1704 Latton Water Treatment Works Tender Change Control Tracker

Issue 01 - 25 April 2025 (work in progress issue)
Issue 02 - 02 May 2025
Issue 03 - 02 May 2025

project	1704	project	Latton Water Treatment Works
document	D07 - 03	title	Tender Change Control Tracker
issue date	02/05/2025	scales shown @ A3

5. Removal of fire escape stair.

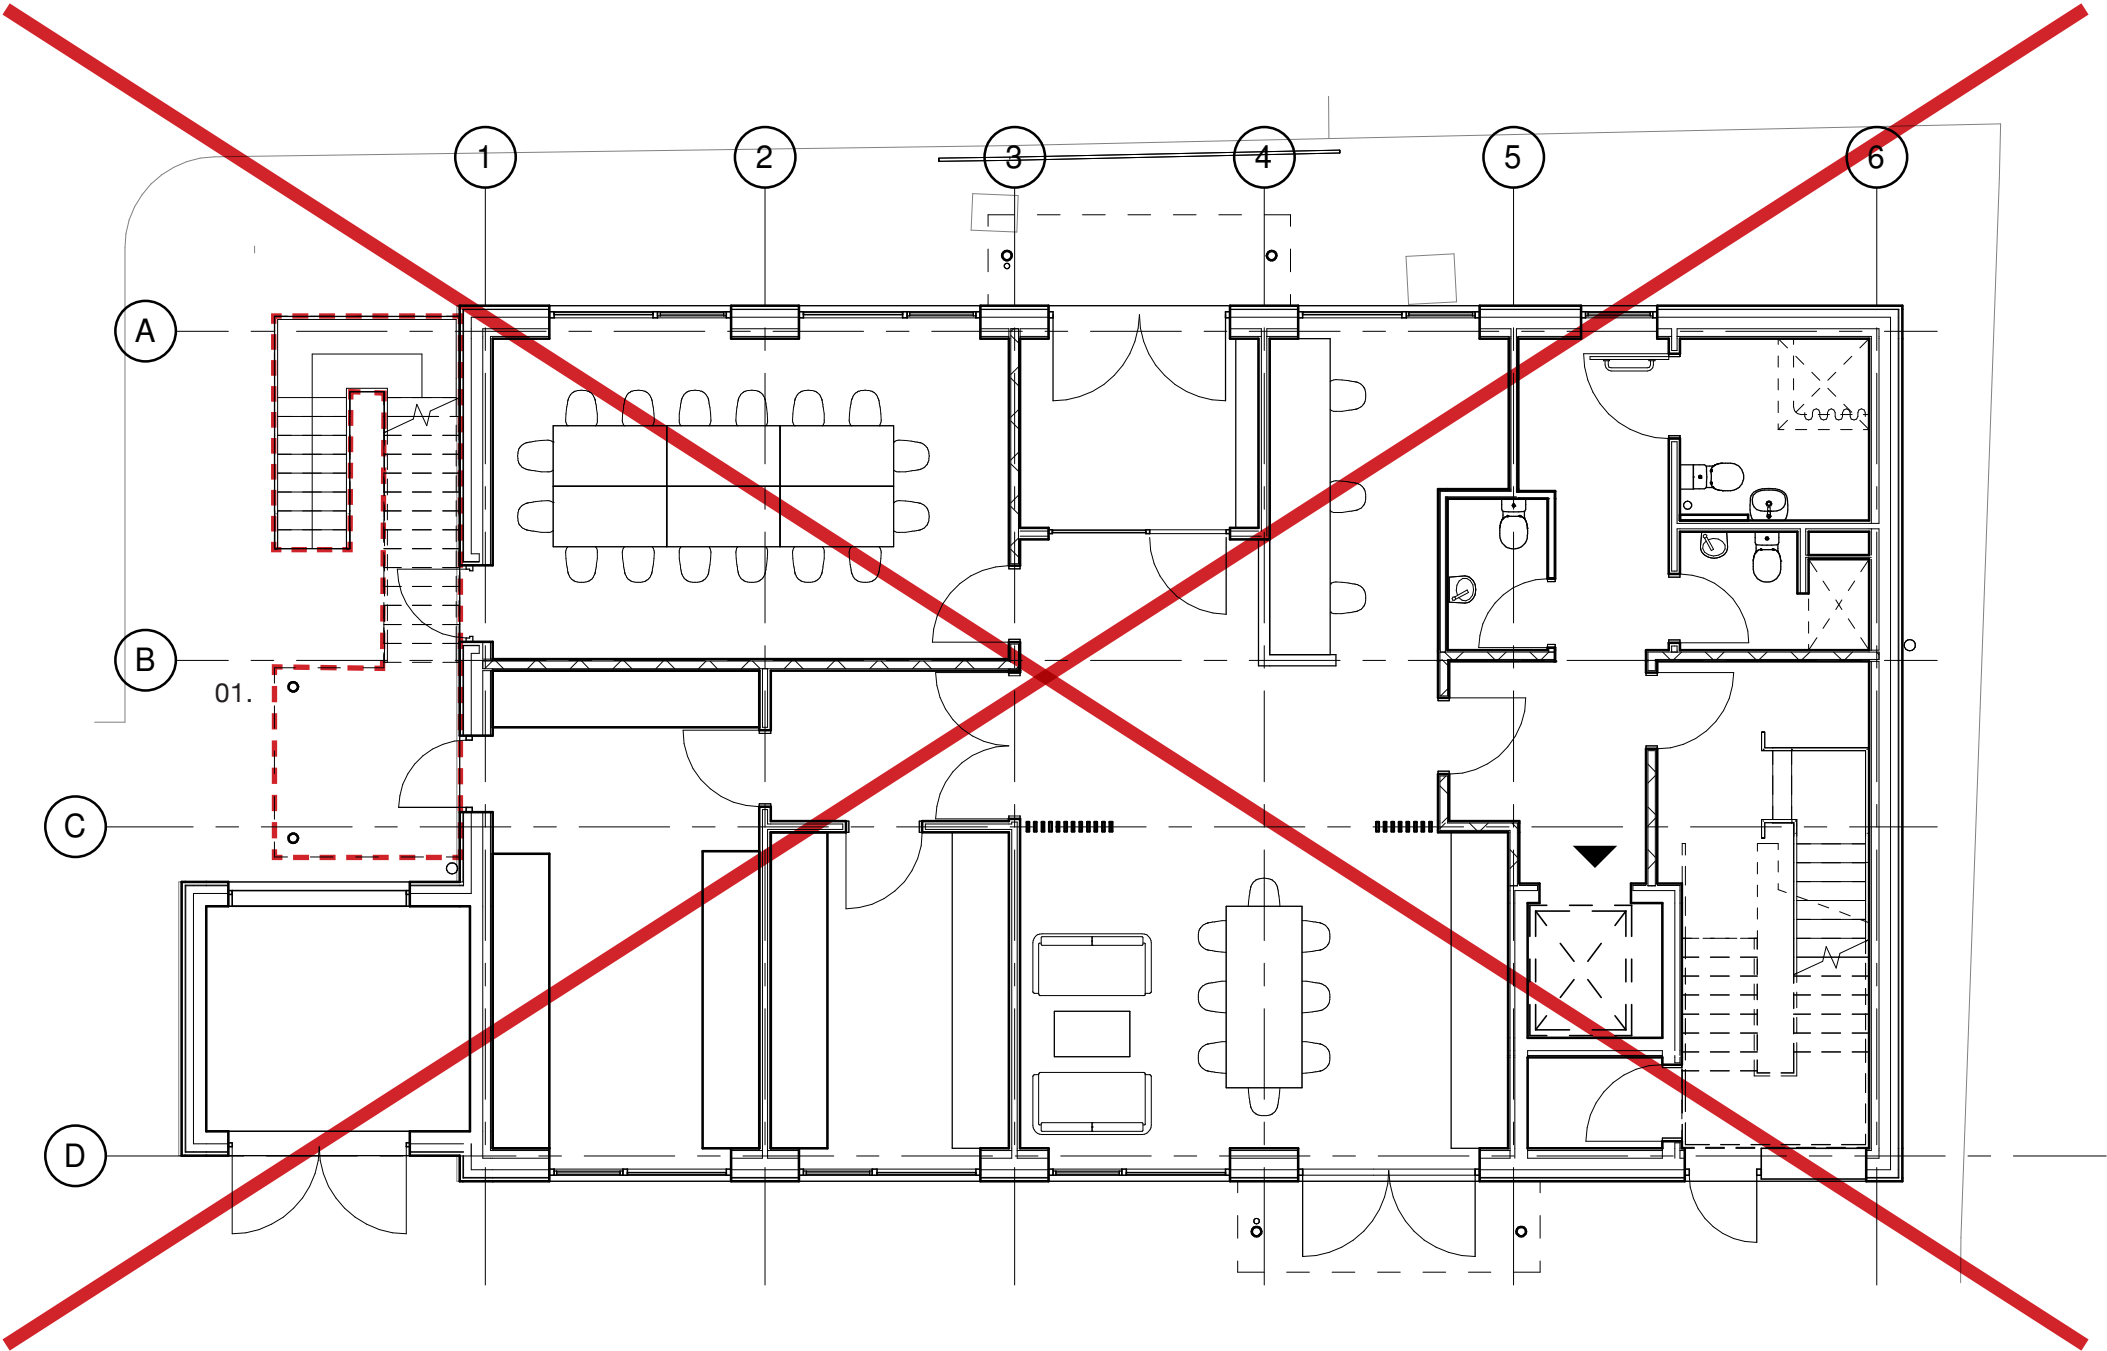
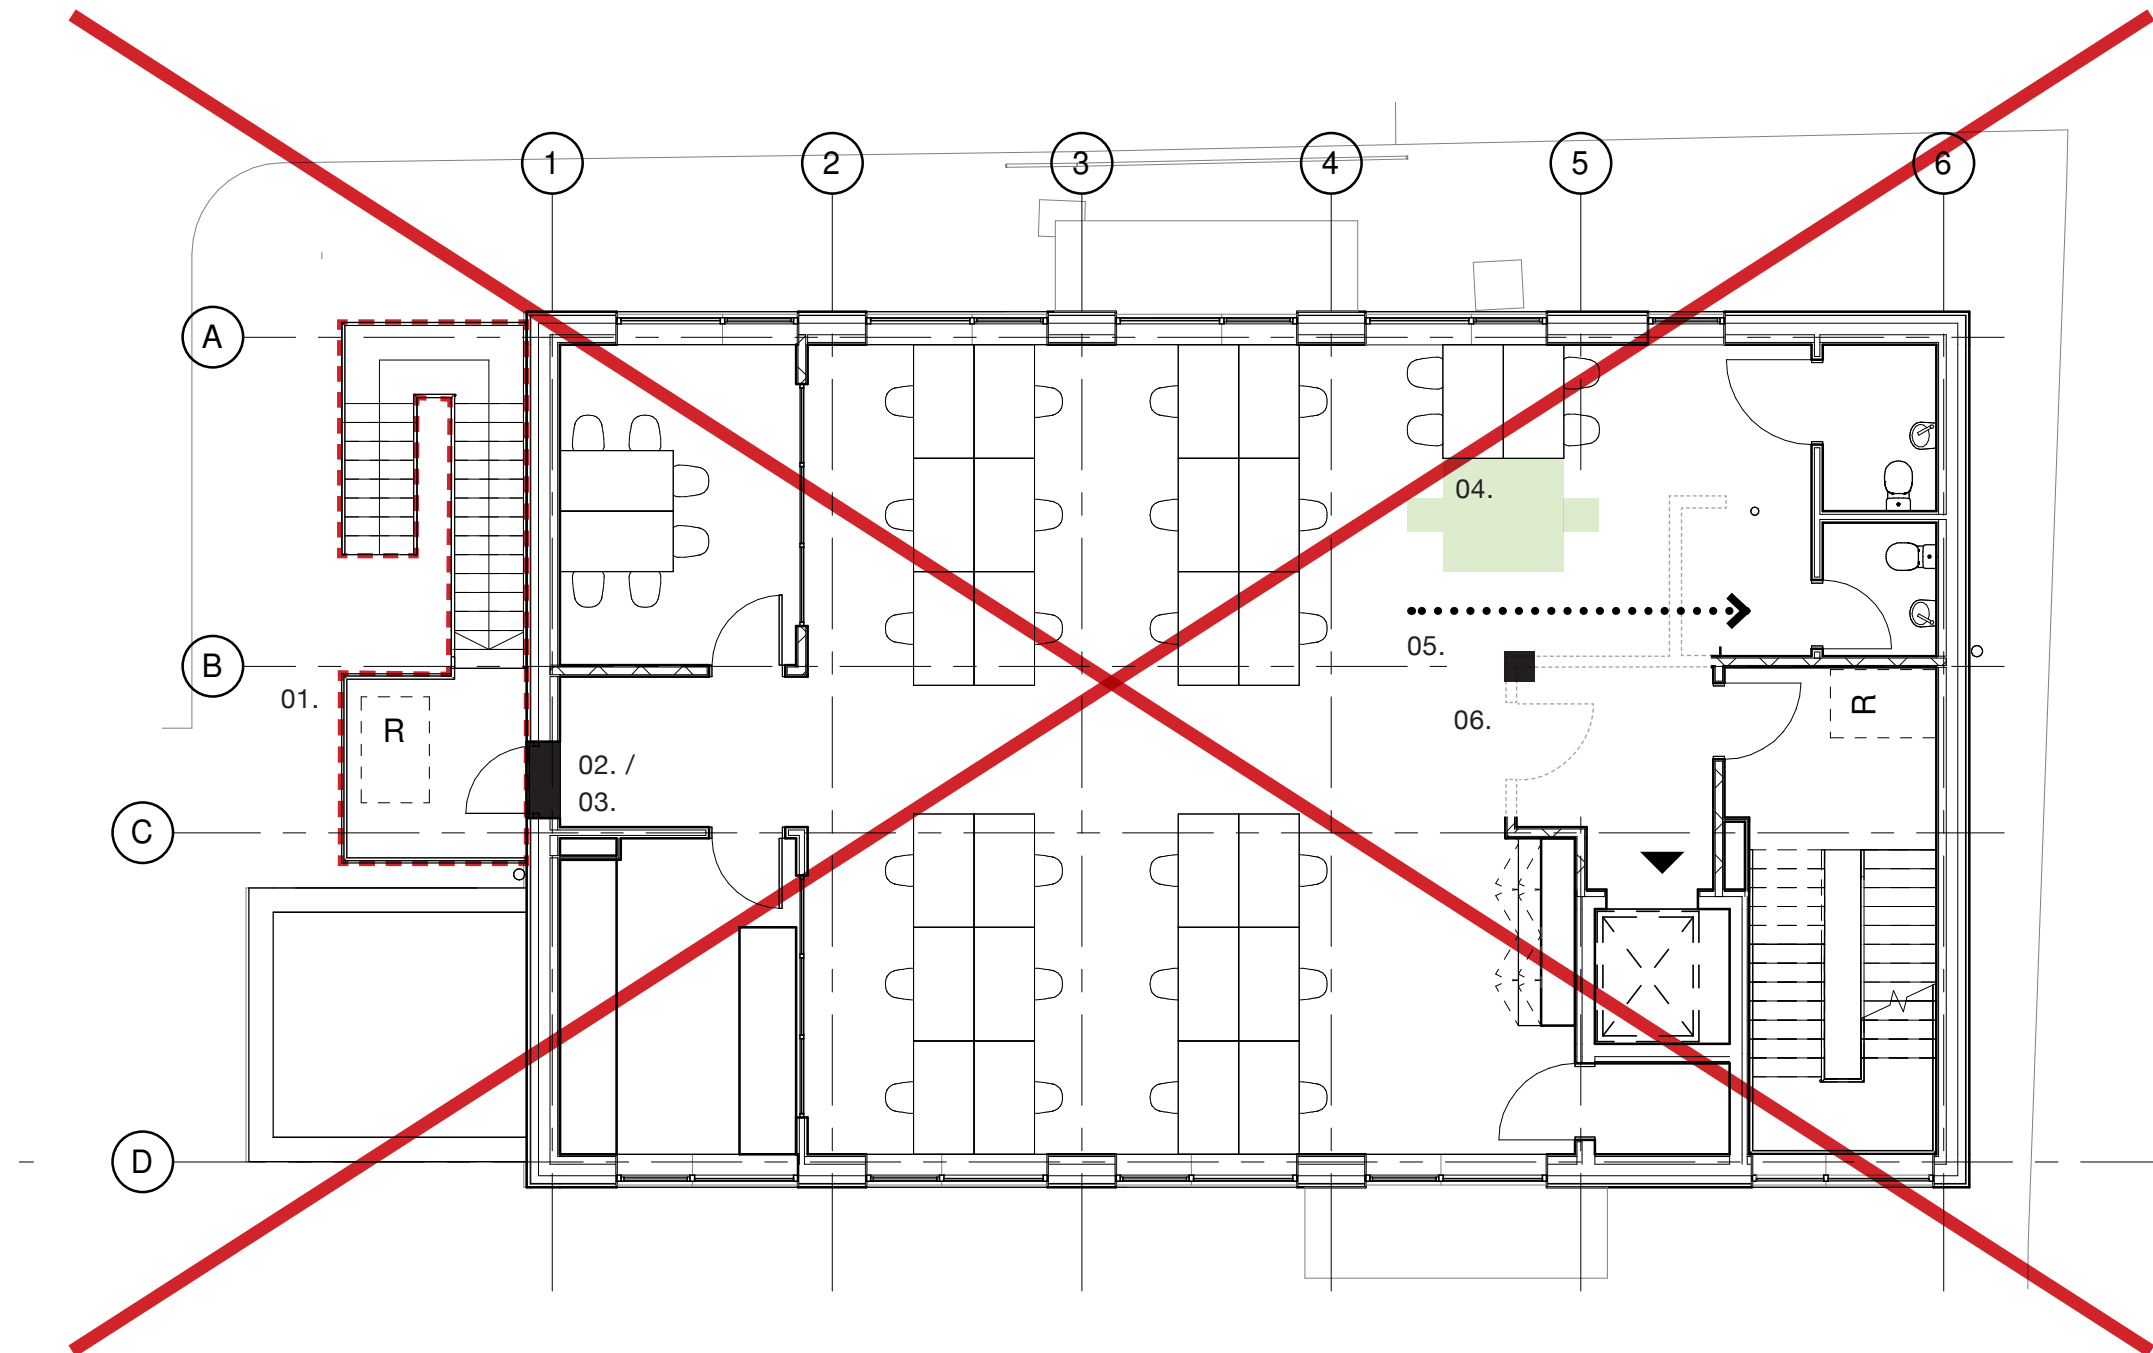
- 01. Remove escape stair
- 02. Remove first floor exit door.
- 03. Repurpose alcove as reprographics area.
- 04. Reinstate additional workstations close to FF WC.
- 05. Alter WC access route.
- 06. To be read in conjuction with amendments 6 and 12.

Suggested by fire engineer..

ADDITIONAL FIRE ESCAPE STAIR TO BE RETAINED,
25/04/2025.

6. Removal / opening up of protected lobbies.

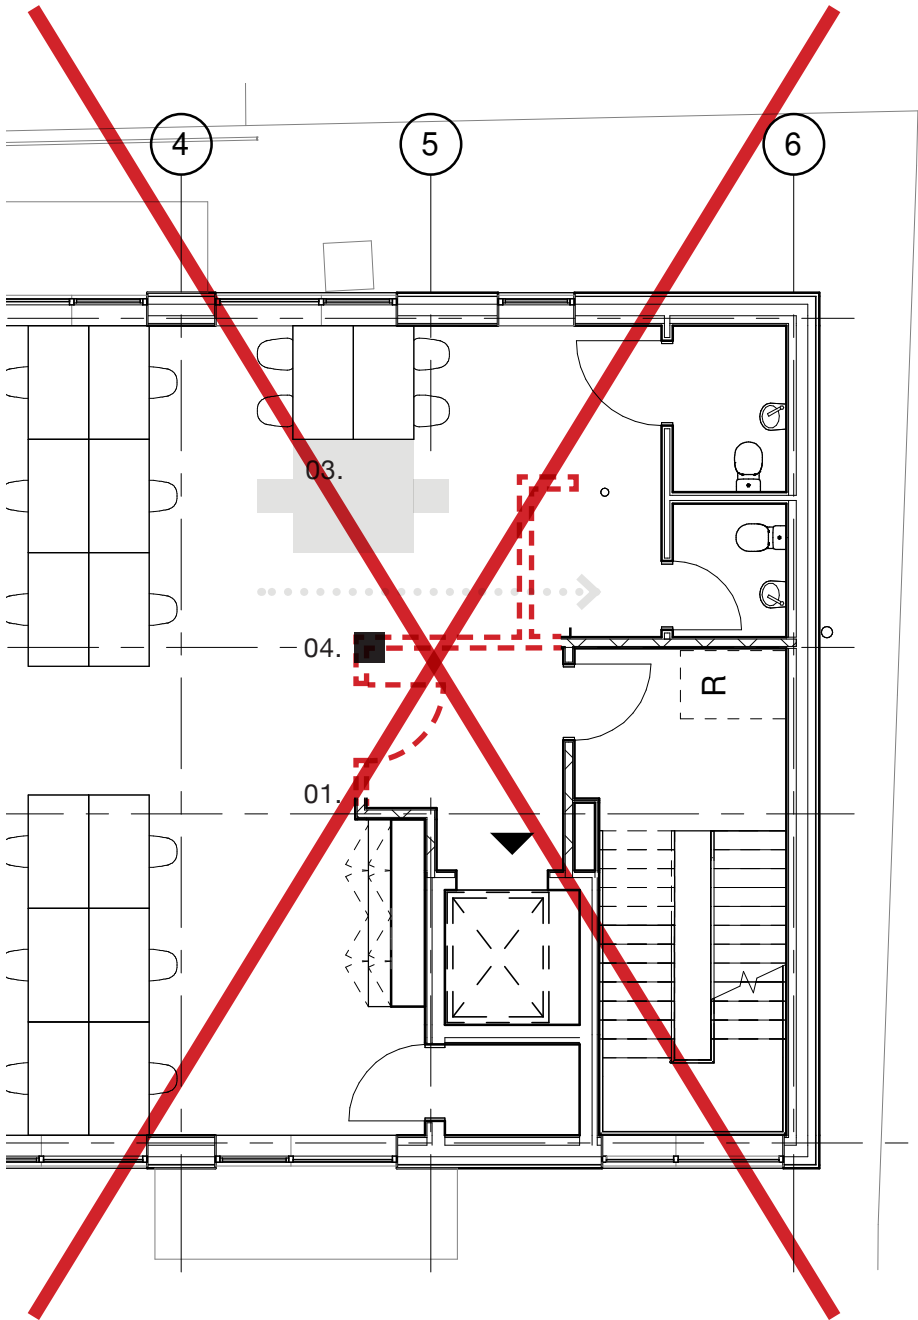
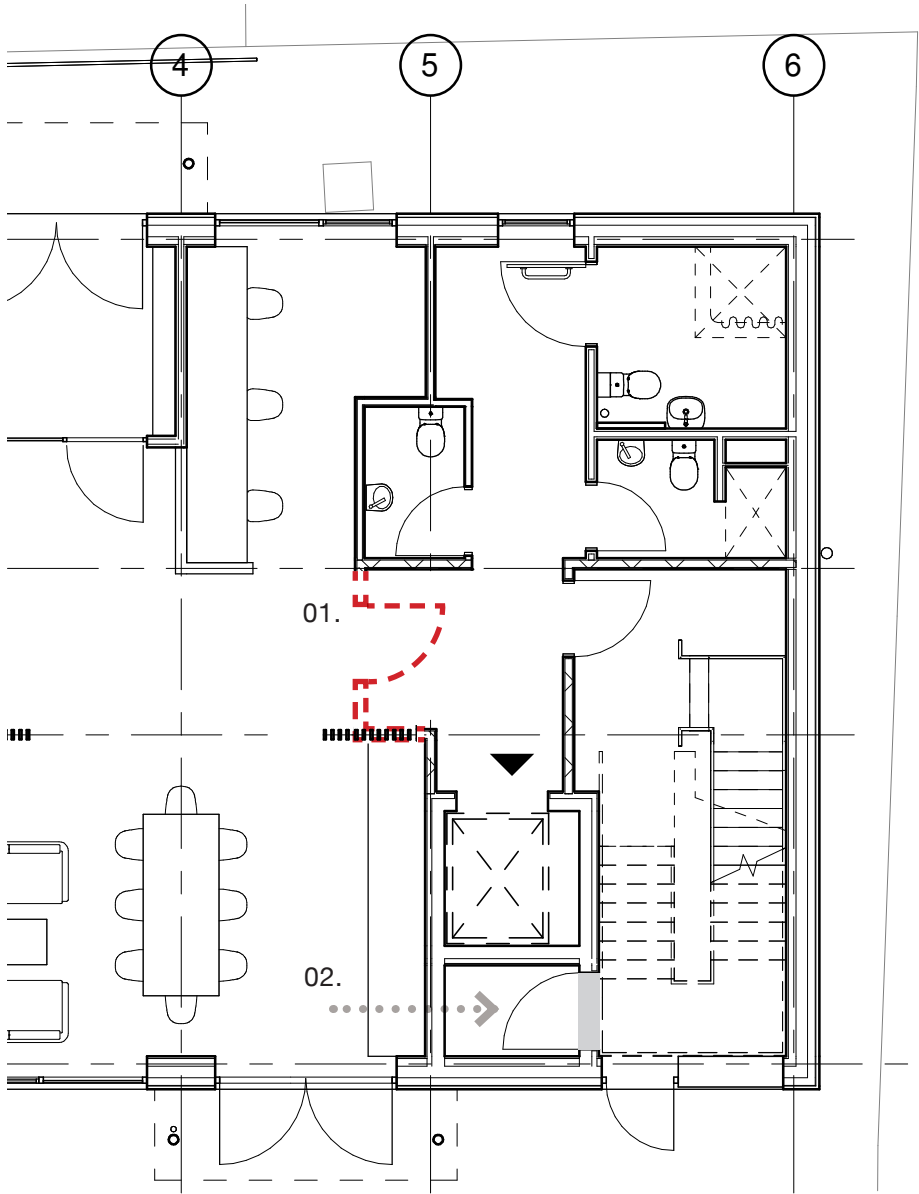
- 01. Remove door and section of wall creating enclosed lobby, both floors.
- 02. For cleaner’s store access refer to amendment 7.
- 03. To be read in conjunction with amendment 5.
- 04. To be read in conjunction with amendment 12.

Deemed not required to meet compliance requirement by fire engineer.

Ground floor lobby to be opened up, first floor lobby to remain. Compartment line to be removed from fire strategy. Subject to comment from building inspector / structural engineer, 24/04/2025.

7. Access to GF cleaner's store changed to kitchen side.

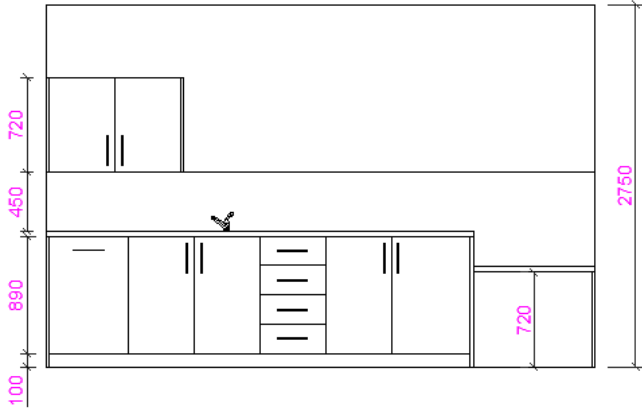
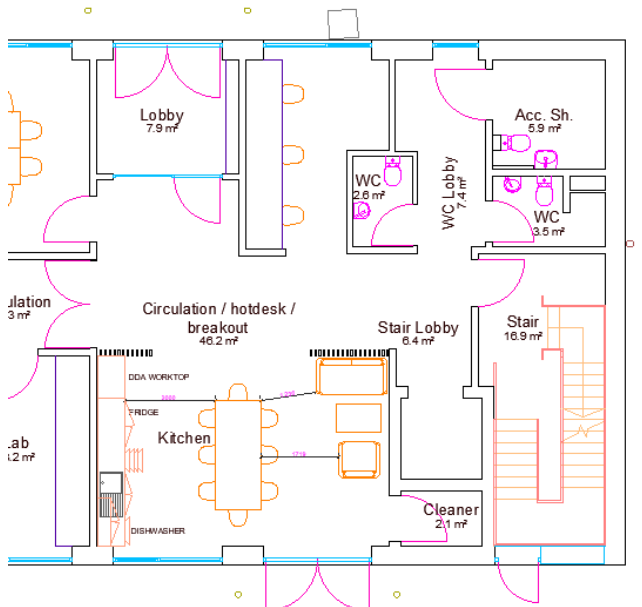
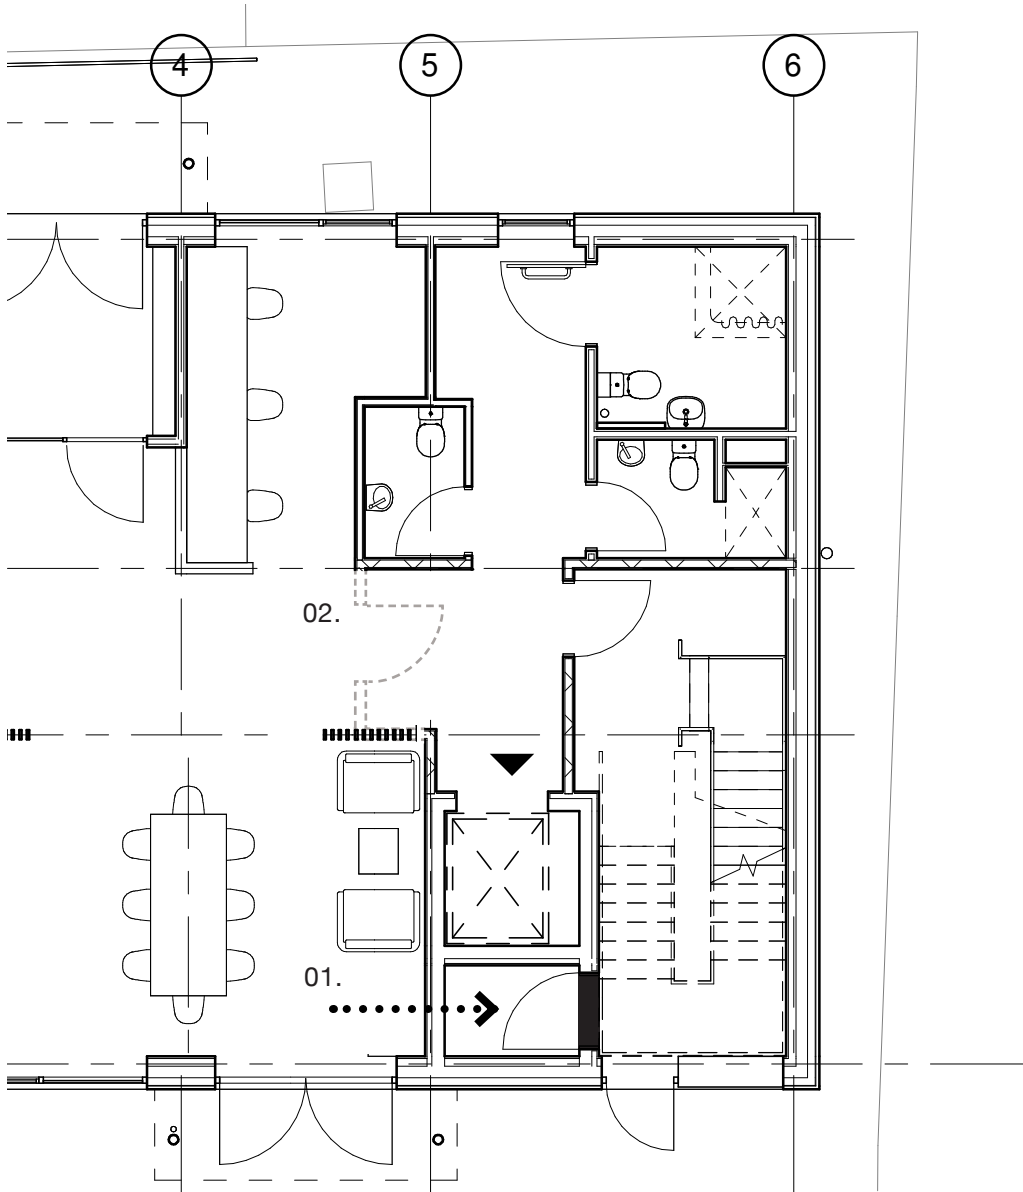
- 01. Change access to cleaner's store to be from kitchen side. Flip kitchen / break-out layout and reduce size of break-out space furniture to provide circulation to external doors and cleaner's store.
- 02. For stair lobby refer to amendment 6.

Suggested by fire engineer.

Agreed 02/05/2025.
